GULF STATES UTILITIES COMPANY

River Bend Station Units 1 and 2
Docket Nos. 50-458/50-459

Enclosed for your review are Gulf States Utilities Company responses to Request for Additional Information identified by the Nuclear Regulatory Commission's Power Systems Branch (PSB). This letter supplements information contained in docketed correspondence from J. E. Booker to H. R. Denton dated December 30, 1983. Attachment 1 contains the actual written changes to the FSAR text including all tables and figures. These changes will be incorporated into the FSAR in a future amendment. Attachment 2 is provided as supplemental information to a previously docketed response for FSAR Question 430.20.

QUESTION 430.21 (8.3)

FIGURE A

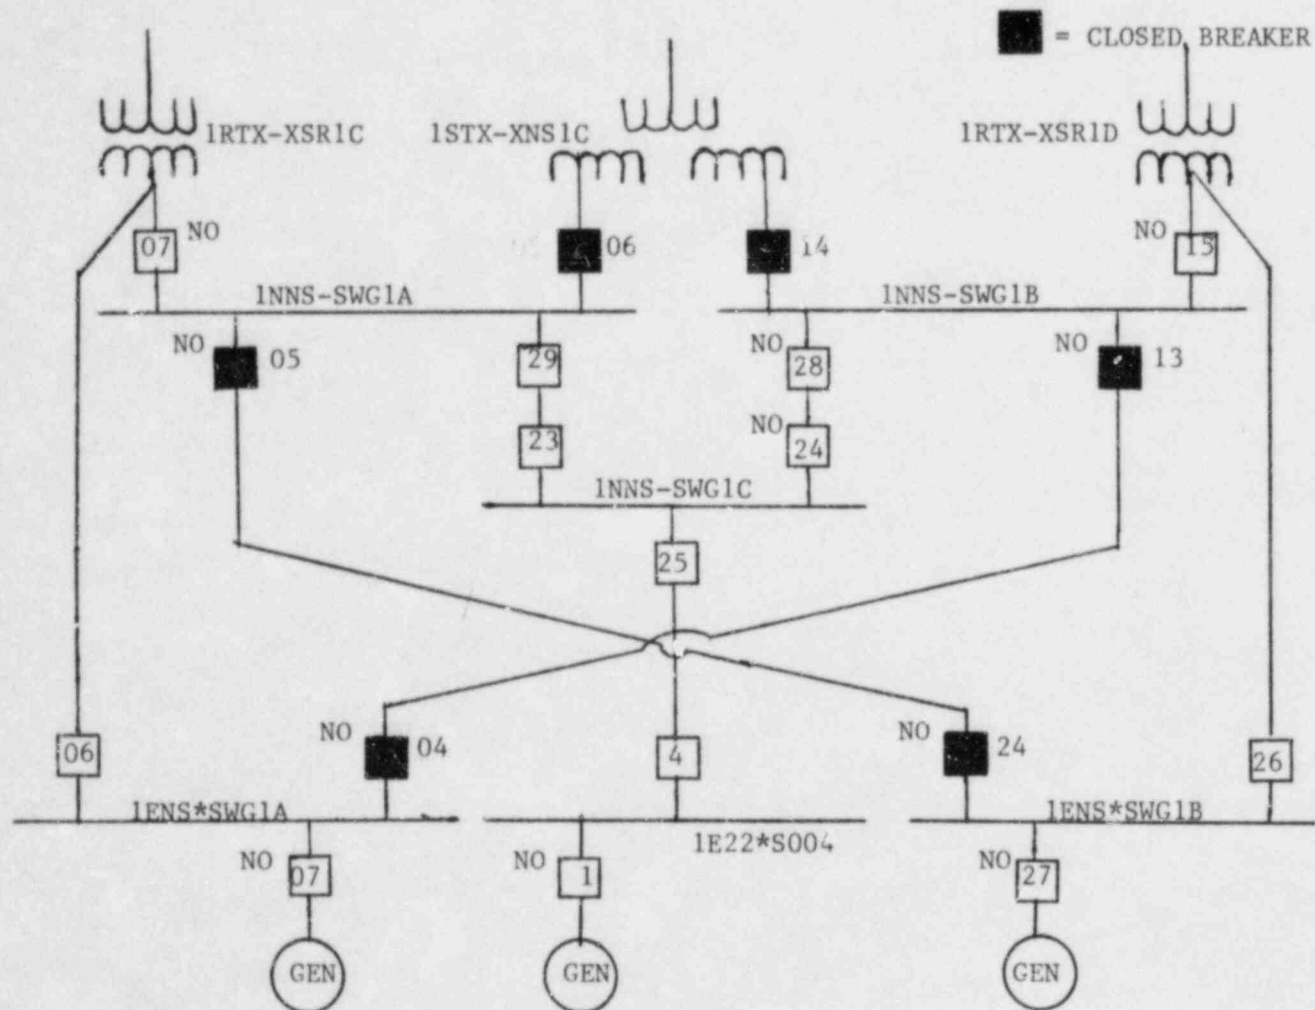
The following is a transfer scheme that analyzes the interaction of the diesel starting logic and normal bus transfer logic when the standby bus is fed through the normal bus and a common loss of power or undervoltage condition occurs (see Figures A, B and C).

I. Upon loss of power (i.e., generator trip), with emergency buses (1ENS*SWG1A and/or 1ENS*SWG1B) being fed through normal buses (1NNS-SWG1A and/or 1NNS-SWG1B), the following would occur:

- 1) 1NNS-SWG1A and 1NNS-SWG1B normal feeder breakers (No's 06 & 14) would trip.
- 2) If bus voltage on 1NNS-SWG1A and 1NNS-SWG1B is greater than 70 percent and other electrical permissives satisfied, fast transfer to preferred source (close preferred supply breakers 07 & 15) - no effect on emergency buses.
- 3) If fast transfer does not occur, residual bus voltage on 1NNS-SWG1A and 1NNS-SWG1B would have to drop below 25 percent to slow transfer.
- 4) If slow transfer occurs in less than 3 seconds there would be no effect on emergency buses.
- 5) If slow transfer takes more than 3 seconds emergency bus feeder breakers (No's 04 & 24) would trip on undervoltage, the diesel generator and load sequence timer would start.

II. On sustained undervoltage (80%) 1NNS-SWG1A and 1NNS-SWG1B feeder breakers (No's 06 & 14) would trip in 2 seconds, if fast transfer does not occur, and slow transfer takes longer than 1 second, the emergency bus feeder breakers (No's 04 & 24) would trip on undervoltage, the diesel generator and load sequence timer would start.

Circuit breakers 06 & 14 AUTO-TRIP
 INNS-SWG1A & INNS-SWG1B voltage is
 greater than 70% (Fast Transfer)
 Residual bus voltage is less than
 25% (Slow Transfer)
 IENS-SWG1A & IENS-SWG1B trip on
 undervoltage is less than 71%
 in three (3) seconds

Circuit breakers 06 & 14 trip at 80%
 in two (2) seconds

FIGURE B

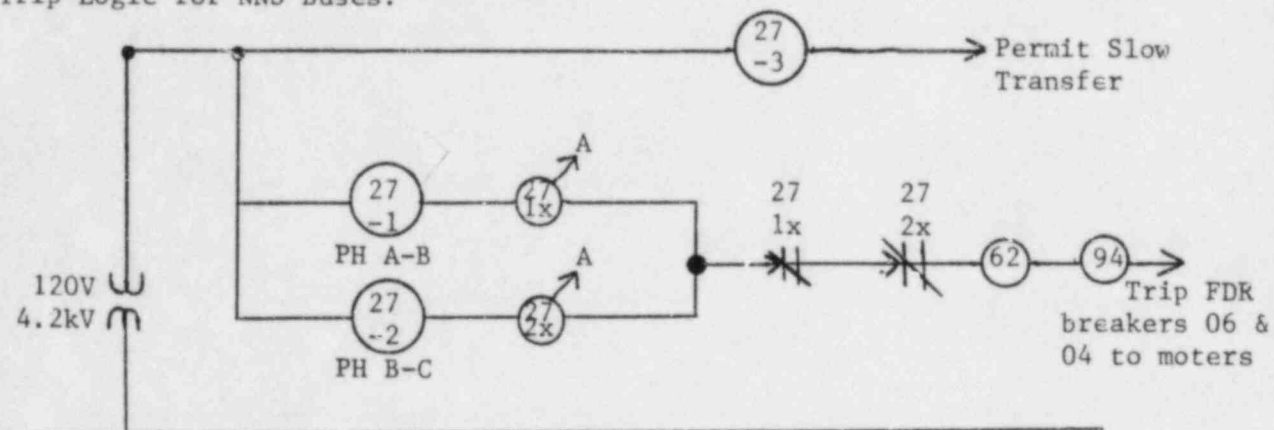
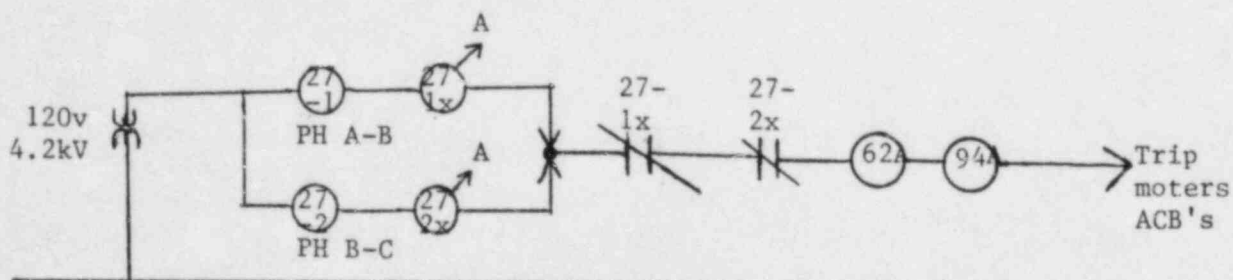
Undervoltage Trip Logic for NNS Buses:

| | | | | | <u>Range</u> | <u>Set</u> |
|----------------------------|--------|----------|---------------|----|---------------|-------------|
| 1NNS-SWG1A & 1NNS-SWG1B | 27-1&2 | 90-105v | 96v (80.77%) | 62 | 0.2-4 sec. | 2.0 sec. |

| INNS-SWG1C | | | | | Range | Set |
|------------|--------|---------|--------------|----|---------------|-------------|
| | 27-1&2 | 90-105v | 96v (80.77%) | 62 | 0.2-4 sec. | 2.0 sec. |

FIGURE C

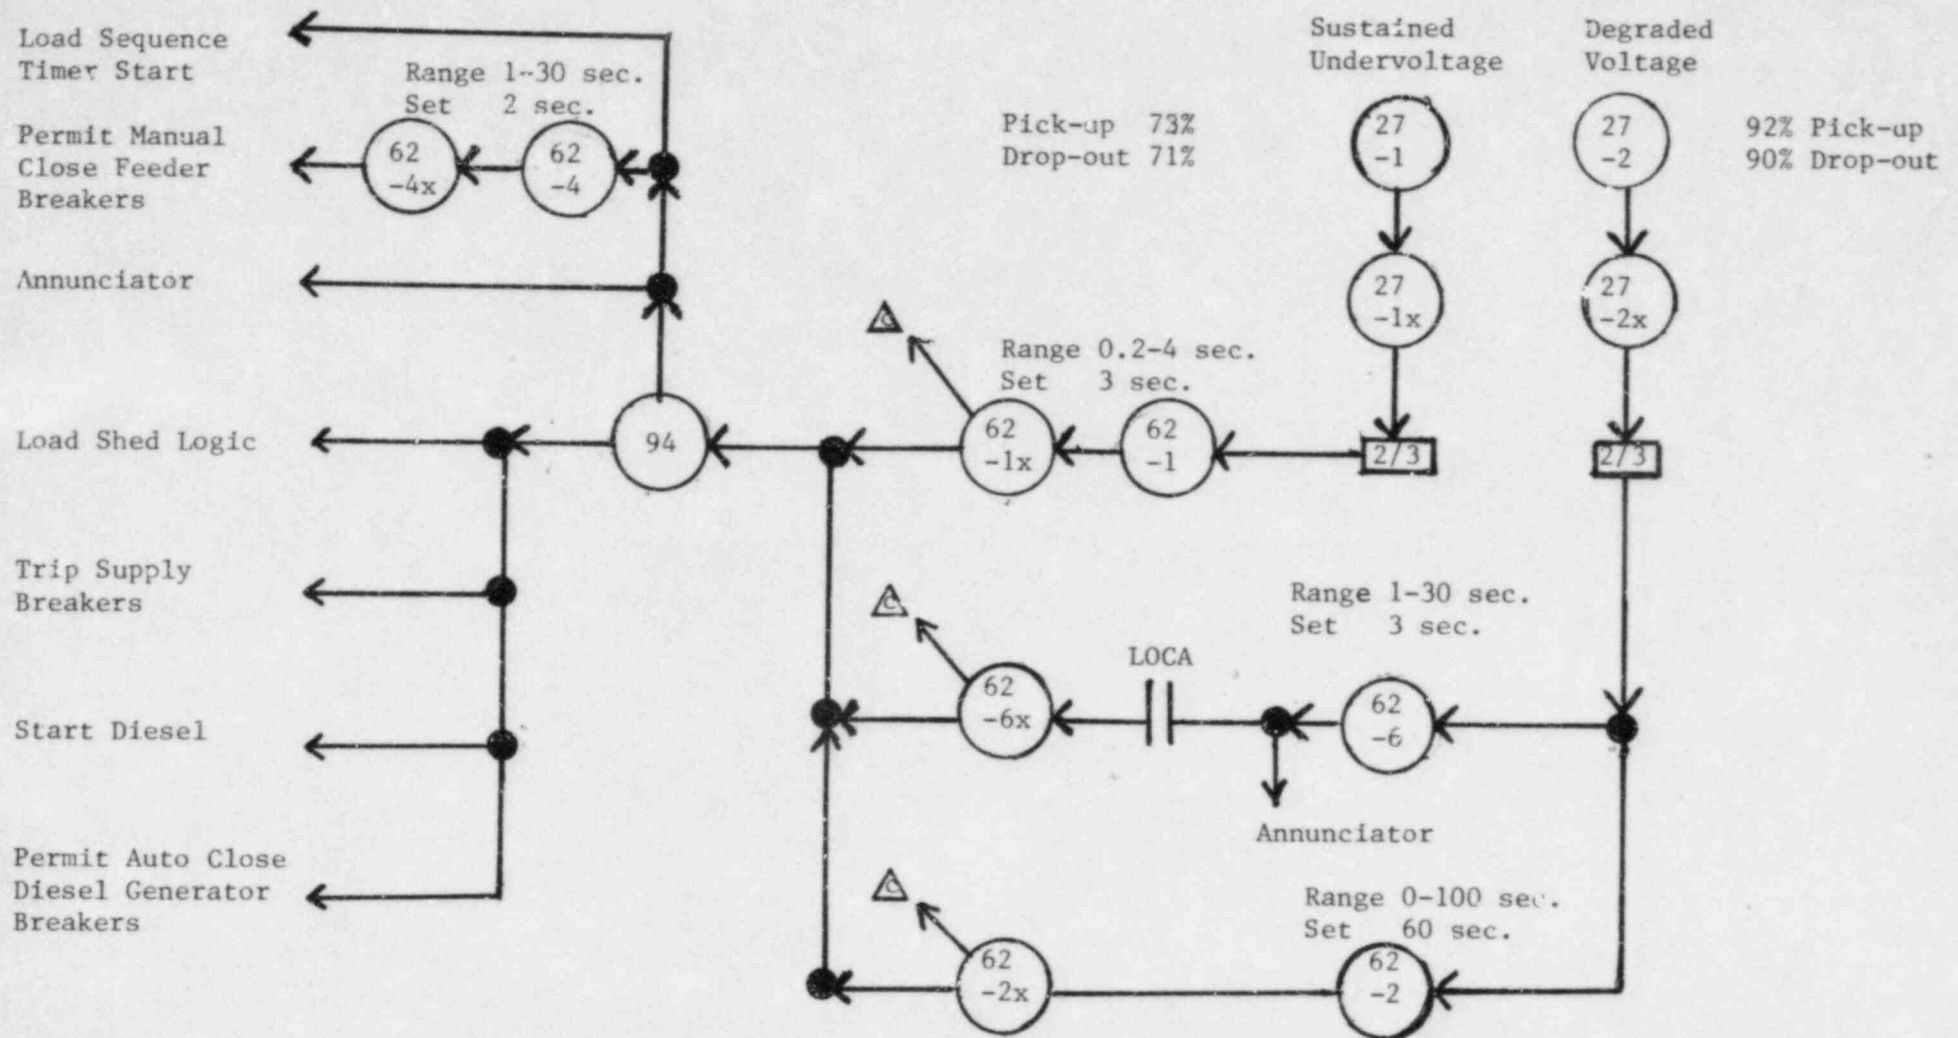
Undervoltage Trip Logic for ENS Buses:

FIGURE D

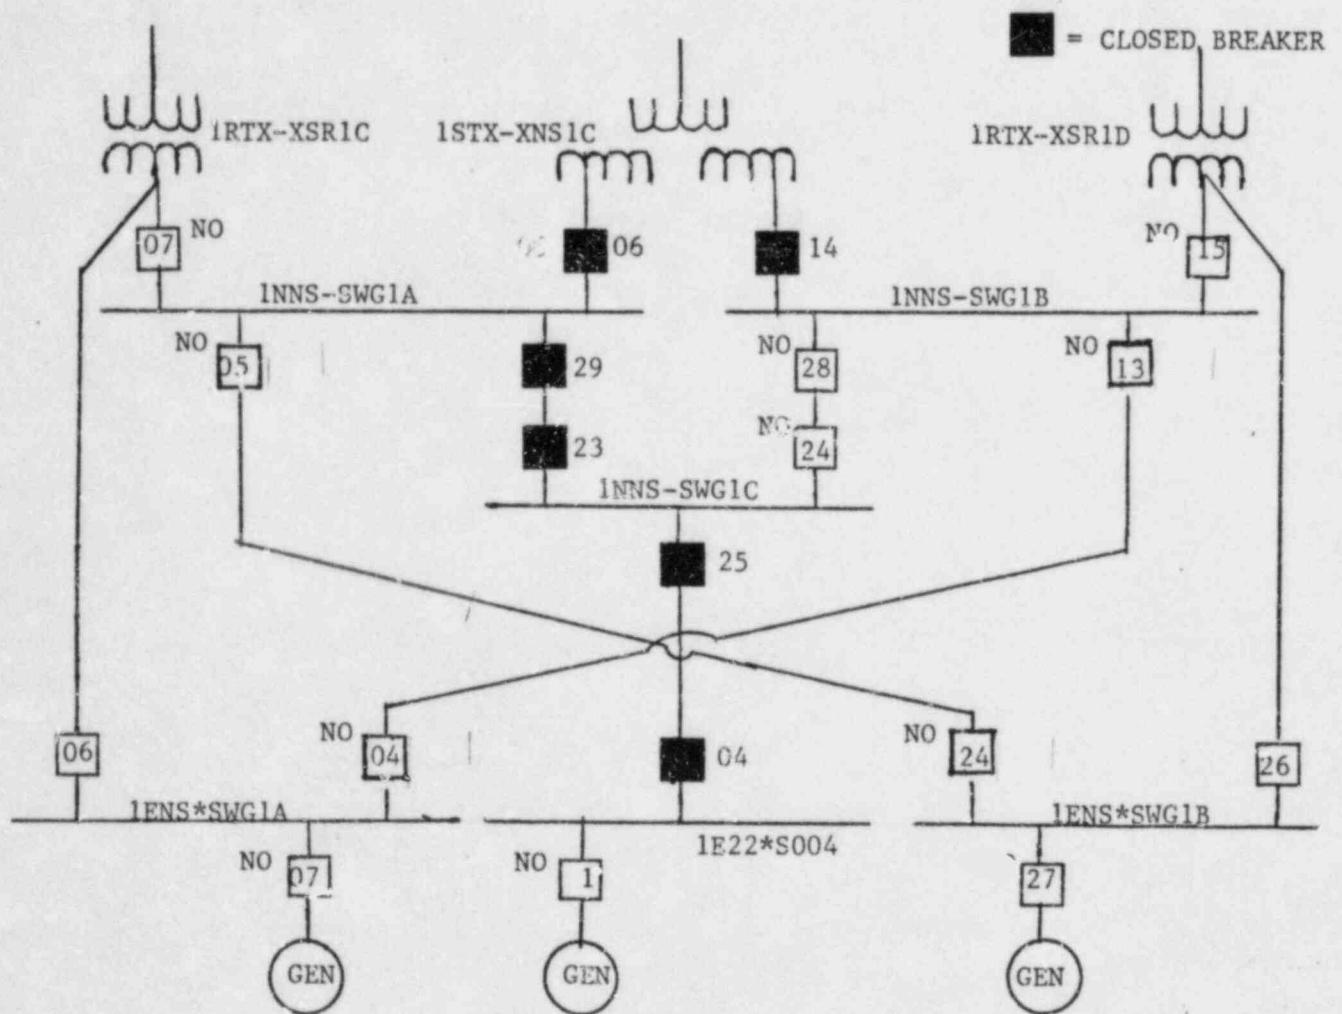
The following is a transfer scheme that analyzes the interaction of the diesel starting logic and normal bus transfer logic when the HPCS standby bus is fed through the normal bus and a common loss of power or undervoltage condition occurs (see Figures D and E).

I. Upon loss of power (i.e., generator trip), with emergency bus 1E22*S004 being fed from normal bus (1NNS-SWG1A or 1NNS-SWG1B) through 1NNS-SWG1C, the following would occur:

- 1) 1NNS-SWG1A and 1NNS-SWG1B normal feeder breakers (No's 06 & 14) would trip.
- 2) If bus voltage on 1NNS-SWG1A and 1NNS-SWG1B is greater than 70 percent and other electrical permissives satisfied, fast transfer to preferred source (close preferred supply breakers 07 & 15) - No effect on 1E22*S004 bus.
- 3) If fast transfer does not occur, residual bus voltage on 1NNS-SWG1A to 1NNS-SWG1B would have to drop below 25 percent to slow transfer.
 - a) If slow transfer occurs in less than 2 seconds there would be no effect on 1E22*S004 bus.
 - b) If slow transfer occurs after 2 seconds 1E22*S004 feeder breaker (No. 04) would trip on undervoltage, then after 2 more seconds the diesel generator would start and permit auto close of the diesel generator breaker (No. 1).

On concurrent undervoltage, 1NNS-SWG1A and 1NNS-SWG1B feeder breakers (No. 06 & 14) and 1E22*S004 feeder breaker (No. 04) would trip in 2 seconds. After 2 more seconds the diesel generator would start and permit to auto close diesel generator (No. 1).
